GOVERNMENT OF INDIA
CENTRAL ELECTRICITY AUTHORITY
(MINISTRY OF POWER)
Sewa Bhawan (North Wing), Room No. 622, 6th Floor,
R. K. Puram, New Delhi-110066
Tel. Fax -011-26103246, e-mail: ssandesh@yahoo.com
Website: www.cea.nic.in

PUBLIC NOTICE

Subject: Draft second amendment in CEA (Technical Standards for connectivity to the Grid) Regulations, 2007 as amended.

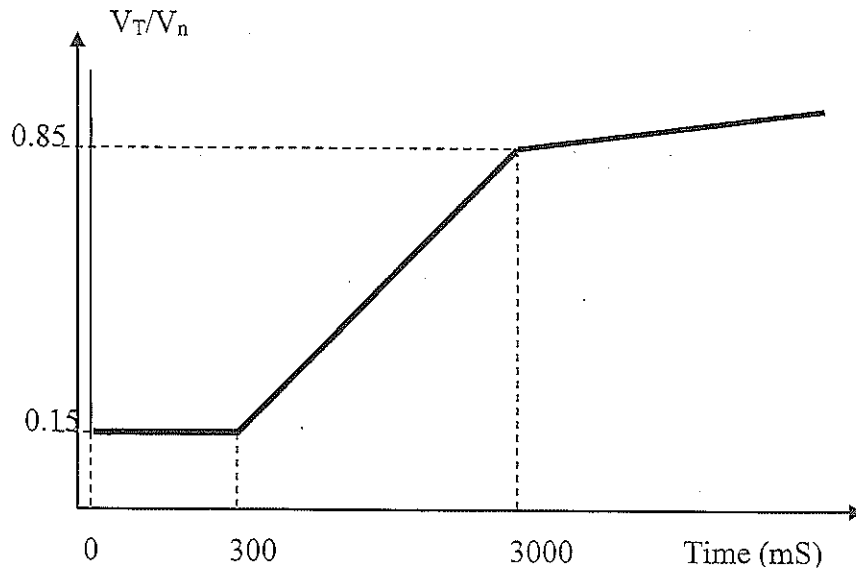
- B(iv).** Sub-Clause (3) of Clause (B2) in Part II of the schedule is proposed to be modified as under to change applicability of the regulation regarding LVRT to both Wind and the Solar generating units/ stations at all voltage levels as against applicability to only Wind generating stations at 66 kV and above in the existing Regulation:

Wind generating stations connected at voltage level of 66 kV and above shall remain connected to the grid when voltage at the interconnection point on any or all phases dips up to the levels depicted by the thick lines in the following curve:

(a). Wind and Solar generating units/stations connected *to the grid*, shall remain connected to the grid when voltage at the interconnection point (measured on HV side of interconnection) on any or all phases dips up to the levels depicted by the thick lines in the following curve:

Provided that during the voltage dip, the Wind and Solar generating units/station shall generate active power in proportion to the rated voltage.

Provided further that during the voltage dip, the generating units/stations shall maximise supply of reactive current till the time voltage starts recovering or for 300 ms, which ever is lower.

High Voltage Ride Through]

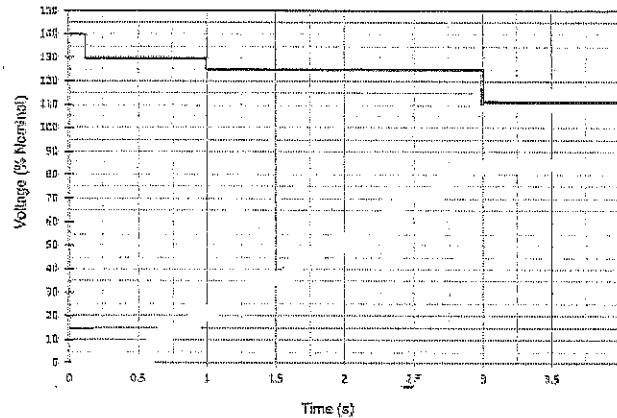
B(v). New provision regarding High Voltage Ride Through (HVRT) facility in Wind as well as Solar generating units / stations is proposed to be inserted after above sub-clause:

(b). Wind and Solar generating units/stations connected at all voltage levels to the grid, shall remain connected to the grid when voltage at the interconnection point, measured on HV side, on any or all phases (Symmetrical or asymmetrical overvoltage conditions) rise above the specified value given below for specified time:

Over voltage (pu)	Minimum time to remain connected (Seconds)
$1.3 < V \leq 1.4$	1
$1.1 < V \leq 1.3$	3
1.1 or below	Indefinitely
